**QUEENSTOWN LAKES DISTRICT COUNCIL
PLAN CHANGE HEARING COMMITTEE**

**PLANNERS' REPORT FOR
PLAN CHANGE 37: QUAIL RISE EXTENSION PRIVATE PLAN CHANGE**

REPORT DATED: September 2010

Figure 1

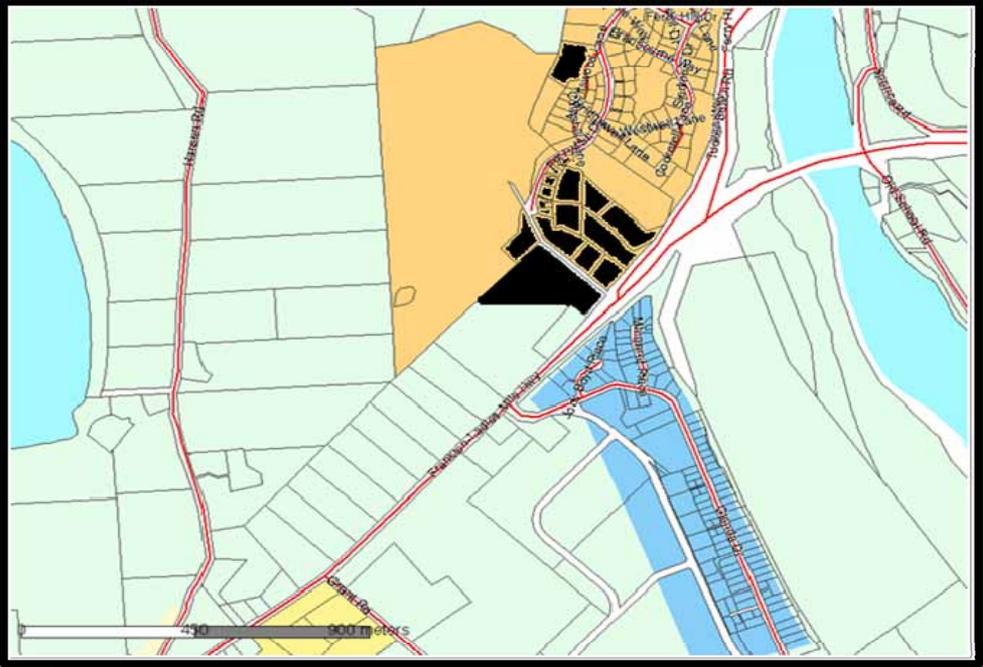
Along its southern boundary the plan change site will border the Transpower transmission lines that diagonally dissect this adjoining rural lot (hence the diagonal shape of the southern boundary). The plan change proposes to establish a 30m setback between the transmission lines and the proposed zone boundary. A further 15m buffer will be provided along the road boundaries of properties that front onto State Highway 6 along the south eastern boundary of the plan change area (Pt Section 20 BLK II Shotover SD, Lot 1 DP 372232 and Lot 2 DP 412992 and Lot 2 DP 346179). This will be provided for by way of a building line restriction which will restrict any building development within this area and provide a setback from the State Highway.

Quail Rise Structure Plan

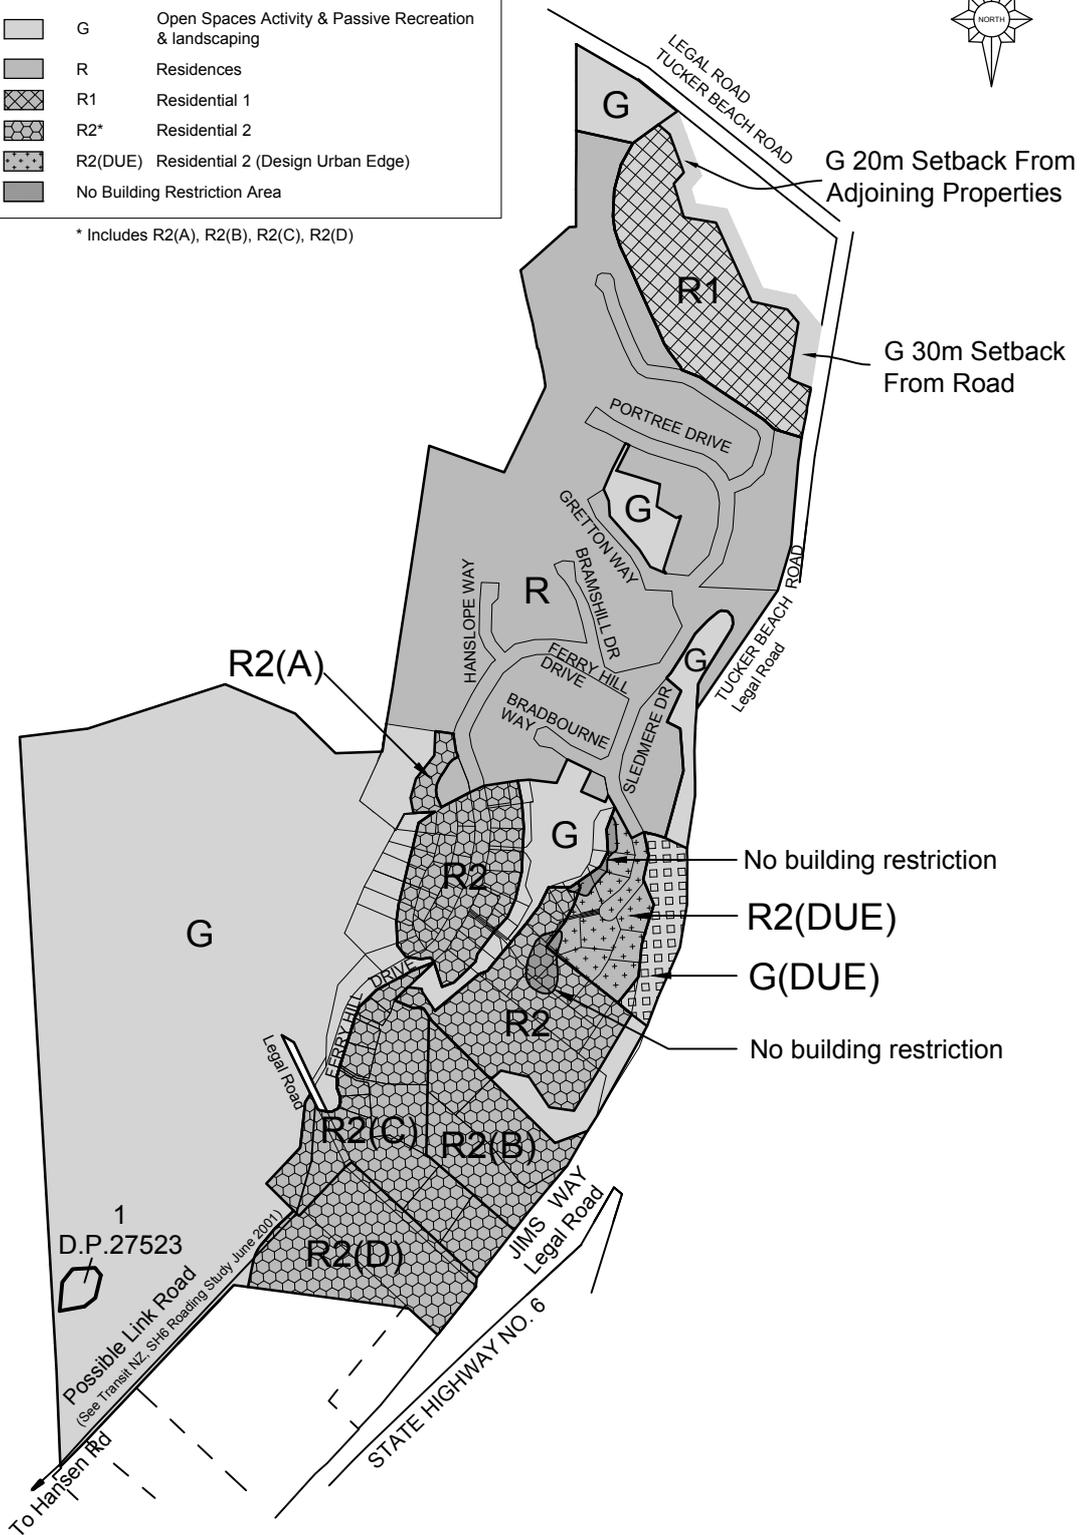
The existing Quail Rise structure plan shows an indicative future link road that could provide a connection from Ferry Hill Drive through to SH6. This road will potentially be an important through route from the Quail Rise zone to Frankton Flats reducing further pressure on the existing Tucker Beach road and SH6 intersection, and providing better integration and connection with the subject site and the land to the south. The majority of this future road will be located outside the proposed plan change site but providing the connection to this link will be vital if the plan change is to proceed. This is recognised in the plan change application in Section 24 which states:

While the initial application sought to retain the road on the structure plan, it provided no further certainty in respect to the location of the road or zone boundary connection. A number of submitters consider that its location should be confirmed prior to approval of the plan change in order to ensure this link is not compromised by residential development in the plan change site. Several landowners located to the south of the site also seek confirmation of the locality of this link road in order to allow them to consider future development options within their sites.

Further information received on the application has confirmed that since notification of the plan change, the Applicant has responded to the above issues by actively engaging with the land owners to the south of the site in order to identify a possible connection and location for this future link road. Within the site the Applicant has amended the plan change to identify the location of the road on a revised planning map. This includes providing for this connection via the existing paper road that borders the southern boundary of the existing Quail Rise zone and the Rural General Zone. This road currently exists as an informal road/driveway connecting Jims Way to the cul de sac at the end of Ferry Hill Drive. As a result, it is proposed to extend this existing paper road through to the south of the site to provide for this future connection (see planning map in Appendix A for detail). The Applicant states:

Accept the submission point that a roading connection must be provided at the zone boundary of the plan change to safeguard this future road alignment south of the plan change area.

Photo D: View of Ferry Hill from Lower Shotover Road (2.33pm 23/8/2010).

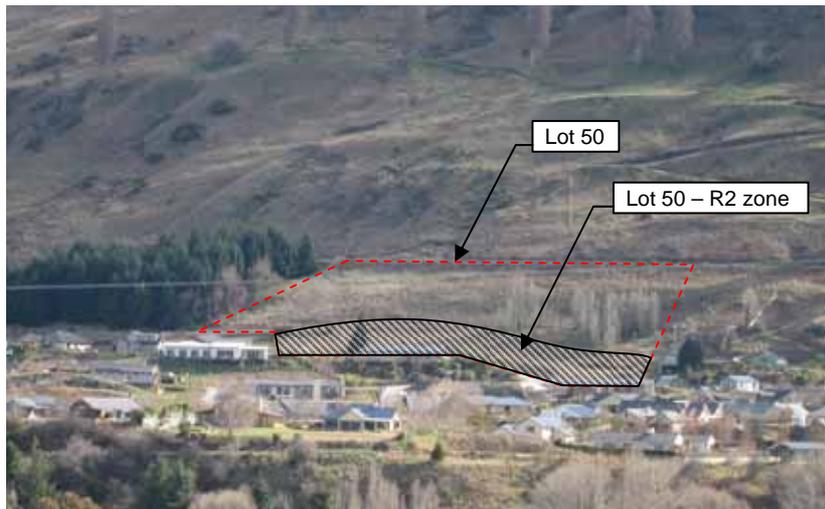
49. Lot 50 is steeper than adjacent sites and provides a break or reprieve in the line of residential development at the base of Ferry Hill. While small, subtle terraces exist, the proposed plan change would result in buildings extending higher on the slope than adjacent buildings, would domesticate the site, and increase visibility of built form, curtilage area, and access ways from areas on the eastern bank of the Shotover River (including the Highway). As discussed above, the proposal would also affect visual and physical access to Ferry Hill.
50. I understand that proposed building platforms on these steep slopes may require protection measures from potential debris flow. I consider that these measures have the potential to contribute to adverse visual effects as well as effects on natural landform (noting that the Arrow Irrigation Race runs along the top of the property).
